TECHNICAL LETTER REPORT
ON THE FOURTH 10-YEAR INTERVAL INSERVICE INSPECTION
REQUESTS FOR RELIEF
FOR
AMERGEN ENERGY COMPANY
OYSTER CREEK GENERATING STATION
DOCKET NUMBER: 50-219

By letter dated August 1, 2002, the licensee, AmerGen Energy Company, submitted Requests for Relief OC-02-01, OC-02-02, OC-02-03, OC-02-04, and OC-02-05 to certain requirements of the American Society of Mechanical Engineers (ASME) Boiler and Pressure Vessel Code, Section XI, *Rules for Inservice Inspection of Nuclear Power Plant Components*. In response to an NRC Request for Additional Information (RAI), the licensee provided further information in a letter dated June 23, 2003. The requests are for the fourth 10-year inservice inspection (ISI) interval at Oyster Creek Generating Station (OCGS). The Pacific Northwest National Laboratory (PNNL) has evaluated the subject requests for relief and proposed alternatives below.

ASME Figure IWB-2500-13, Integral Attachment Weld (typical).

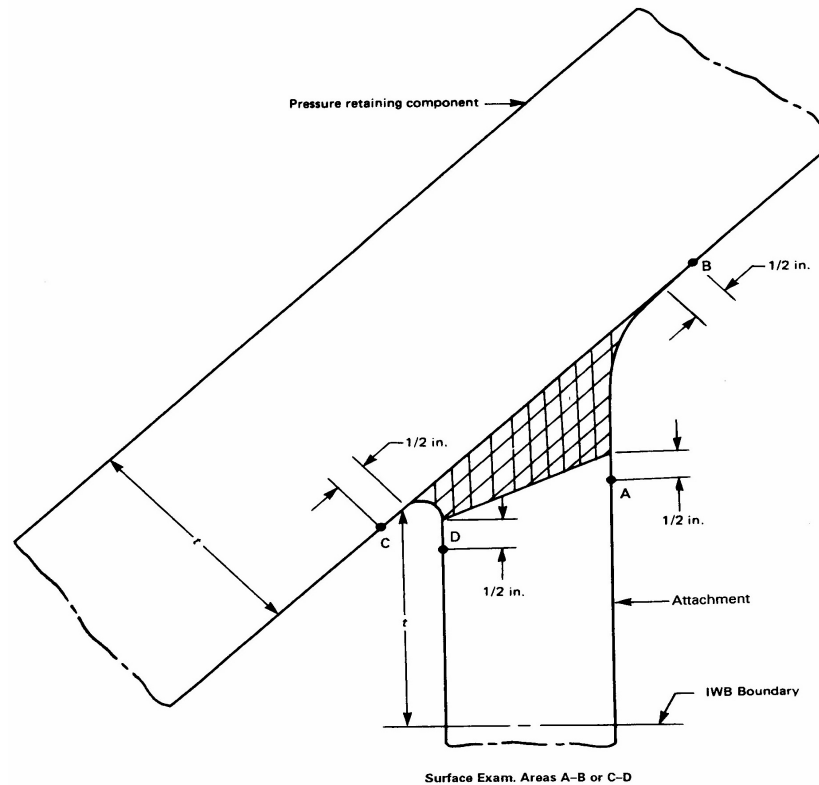
Code Requirement: Examination Category B-K, Item B10.10, requires essentially 100% surface examination, as defined by Figure IWB-2500-13, of the length of both the interior and exterior surfaces of the reactor pressure vessel (RPV) support skirt attachment weld (see Figure 1 below). "Essentially 100%," as clarified by ASME Code Case N-460, is greater than 90% coverage of the examination volume, or surface area,

Licensee's Relief Request: Pursuant to 10 CFR 50.55a(g)(5)(iii), the licensee is requesting relief from performing the surface examination on the interior portions of the RPV support skirt attachment Weld 1-569 and adjacent base material.

Pursuant to 10 CFR 50.55a(g)(5)(iii), relief is requested on the basis that the Code requirements to examine essentially 100% of the surface areas is impractical due to physical obstructions and geometric interference. Control rod drive housings and instrumentation penetrations restrict the examination of area C-D as required by Figure IWB-2500-13. The physical location of the drives and instrumentation penetrations, and the design of the vessel skirt, prohibit access to area C-D. Area A-B as shown in Figure IWB-2500-13 remains accessible for surface examination to the extent required by the Code.

As an alternative to the Code requirement to perform a surface examination of areas A-B and C-D, AmerGen proposes to perform the following:

1. Perform a surface examination of area A-B as required by Table IWB-2500-1, Category B-K,
2. Perform a VT-3 visual examination of the support skirt IWB boundary as shown in Figure IWB-2500-13 for any support member deformation.

Actual configuration of Weld 1-569 showing areas to apply ultrasonic scans for the inside surface area C-D.

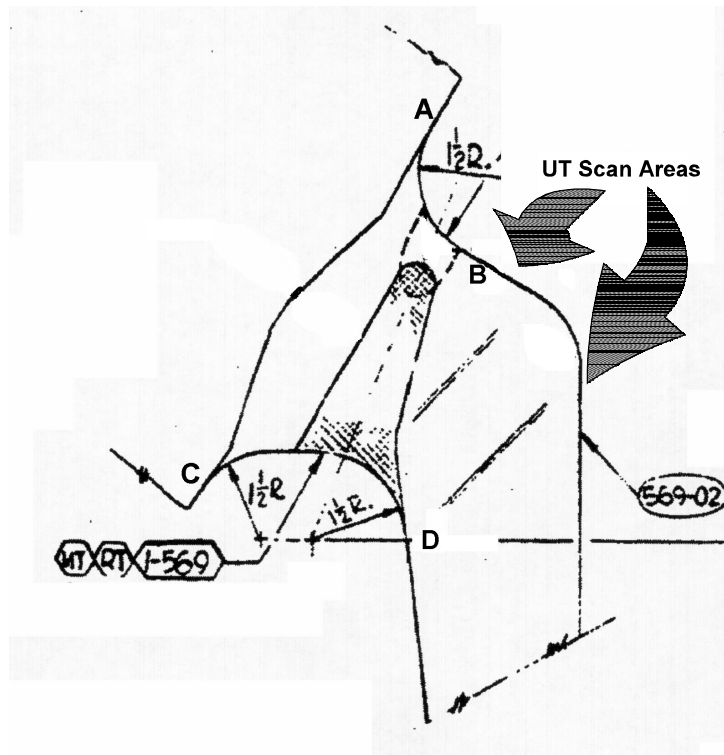
Evaluation: The Code requires the licensee to perform essentially 100% surface examination of both the inside and outside surfaces of reactor pressure vessel (RPV) support skirt Weld 1-569. However, access to the inside surface is severely restricted due the presence of control rod drive and in-core instrumentation housings and electrical lead conduits. In addition, no personnel entry or inspection ports are provided in the OCGS support skirt design. Therefore, surface examination of the inside surface is impractical. To gain access to perform limited surface examinations would require the licensee to make design modifications to the RPV support skirt. This would place a significant burden on the licensee.

The licensee is performing 100% of the Code-required surface examination on the outside surface of RPV support skirt Weld 1-569. The Code designates this outside surface of the integral attachment weld as area A-B, and the inside surface as area C-D. Areas A-B and C-D include the weld and ½-inch of base material on either side of the weld for each surface over the length of the weld (see Figure 2). The licensee has also proposed to perform a visual VT-3 of the outside surface of the IWB support boundary in order to detect deformation that might be manifested on this surface.

The inspections performed by the licensee should detect any degradation that might be present on the outside surface of RPV support skirt integral attachment Weld 1-569. However, their proposed alternative examination does not include any provisions for assuring gross degradation is not present on the inside surface of this weld. The licensee stated that an ultrasonic examination of the inside surface applied from the outside was considered, but that the 1-1/2-inch blend radius on the weld surface demonstrates limited capability to conduct this examination. Based on the drawings¹ provided by the licensee, it is the Staff's opinion that ultrasonic examination methods may indeed provide further information to ensure that inside surface-breaking flaws are not present. As shown in Figure 2, it appears that relatively simple techniques, applied from the outside surface in the areas above and below the support skirt "shoulder"

region should provide reasonable assurance that no significant structural discontinuities exist that may be generated from the inside surface of Weld 1-569. In fact, other licensee's are applying similar volumetric alternatives to examine the inside surface regions on RPV integral attachment welds.

The licensee has shown that it is impractical to access the inside surface area C-D of RPV support skirt integral attachment Weld 1-569 for the Code-required surface examination. The licensee is able to obtain 100% of the Code-required surface examination of the outside surface area A-B, providing reasonable assurance that any flaws generated from the outside surface will be detected. However, the licensee's alternative, to perform a VT-3 visual inspection, of the outside IWB boundary region does not provide reasonable assurance that no inside surface flaws exist. Therefore, pursuant to 10 CFR 50.55a(g)(6)(i), it is recommended that the licensee's request be granted, with the provision that the licensee develop and implement ultrasonic techniques for detecting surface-breaking flaws on the inside surface region C-D of Weld 1-569.

Further, the Staff concludes that the Code examination coverage requirements are impractical for the inside surface of RPV support skirt integral attachment Weld 1-569 listed in Request for Relief OC-02-02. However, it is feasible to apply an ultrasonic technique, from the outside base material surface, to assess the condition of the inside surface of this full-penetration attachment weld. Other licensees are currently performing similar ultrasonic examinations to ensure that no conditions that would challenge the structural integrity of this attachment weld exist. The outside surface examinations that are being completed, in conjunction with new ultrasonic examinations, if performed, should provide reasonable assurance of the continued structural integrity of this component. Therefore, pursuant to 10 CFR 50.55a(g)(6)(i), it is recommended that relief be granted for the remainder of the fourth 10-year inspection interval at OCGS, provided the licensee implement the aforementioned ultrasonic examination. This authorization is limited to the components described in Section 3.2 above.
